GAM5A CNT05981 Fan Control to RLY02807

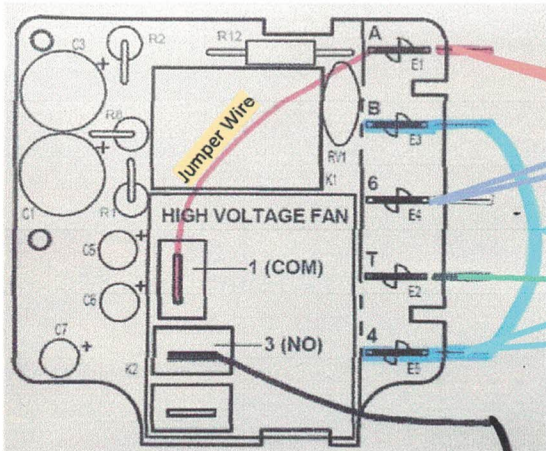
Cut wires off CNT05981 Time Delay plug, add ¼" terminal to attach to RLY02807 terminals

Yi (YL) Wire – Cut wire and cap – Do not use

WI (WH) Wire – Cut wire and cap – Do not use

LOW (RD) – Cut wire and cap – Do not use
